UNITED STATES PATENT AND TRADEMARK OFFICE

Office Action Summary	Application No. 10/689,976	Applicant(s) RINNE, GLENN ET AL.	
	Examiner Jennifer Matisiak	Art Unit 2811

DETAILED ACTION

Fig. 1

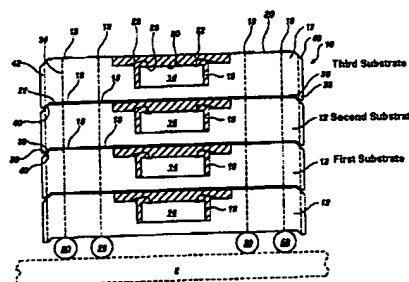
Regarding claim 42, Moden discloses an electronic device (Fig. 1 as shown below, for example) comprising: a first electronic substrate (Fig. 1 as shown below) having opposing first and second

surfaces; a second electronic substrate on the first electronic substrate, the second electronic substrate having opposing first and second

surfaces; a third electronic substrate, on the

second electronic substrate, the third electronic substrate having opposing first and second surfaces, wherein the second electronic substrate is between the first and third electronic substrates; and a signal path (24 of

Fig. 2, for example) extending along the first surface of the second electronic substrate (Fig. 1), to the second surface of the first electronic substrate (Fig. 1), along the second surface of the first electronic substrate (24 of Fig. 2 through 14 of Fig. 1), to the first surface of the third electronic substrate (Fig. 1), along the first surface of the third electronic substrate (24 of Fig. 2 through 14 of Fig. 1), and to the second surface of the second electronic substrate.

Regarding claim 43, Moden discloses an electronic device (Figs. 1 and 2) wherein the signal path comprises a first conductive trace (24 of Fig. 2 as aforementioned above) on the first surface of the second electronic substrate (as aforementioned above), a first electrical and mechanical connection between the first surface of the second electronic substrate and the second surface of the first electronic substrate (18 of Fig. 1), a second conductive trace (24 of Fig. 2 as aforementioned above) on the second surface of the first electronic substrate, a second electrical and mechanical connection between the second surface of the first electronic substrate and the first surface of the third electronic substrate (18 of Fig. 1), a third conductive trace of the first surface of the third electronic substrate (24 of Fig. 2 as aforementioned above), and a third electrical and mechanical connection between the first surface of the third electronic substrate and the second surface of the second electronic substrate (18 of Fig. 1).

Fig. 4

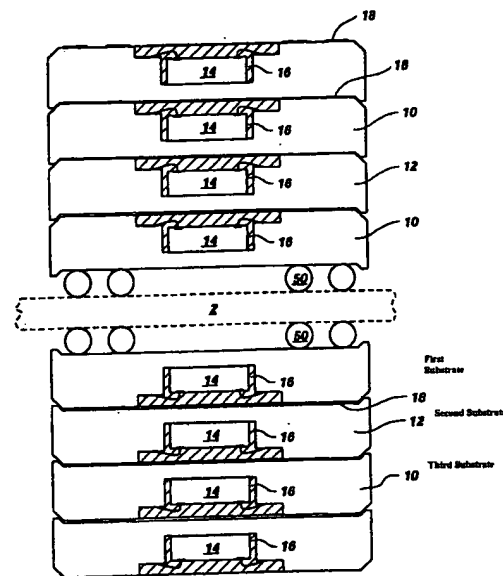
Regarding claim 45, Moden discloses an electronic device (device below substrate 2 of Fig. 4) wherein the first and third electronic substrates comprise integrated circuit devices (14 of Fig. 4), wherein the first side of the first

(10 of Fig. 4) and third (10 of Fig. 4)

electronic substrates comprises a device side and wherein the second side of the first and third electronic substrates comprises a backside.

Regarding claim 46, Moden discloses an electronic device (Fig. 4) wherein the signal path is electrically coupled (18 of Fig. 4) to an electronic circuit of the third electronic substrate.

Regarding claim 47, Moden discloses an electronic device (Fig. 4) wherein the second electronic substrate comprises an integrated circuit device, wherein the first side of the second electronic substrate comprises a device side and wherein the second side of the second electronic substrate comprises a backside (14 of Fig. 4).

Regarding claim 48, Moden discloses an electronic device (Fig. 4) wherein the signal path is electrically coupled to an electronic circuit of the second electronic substrate and to an electronic circuit of the third electronic substrate (18 of Fig. 4).
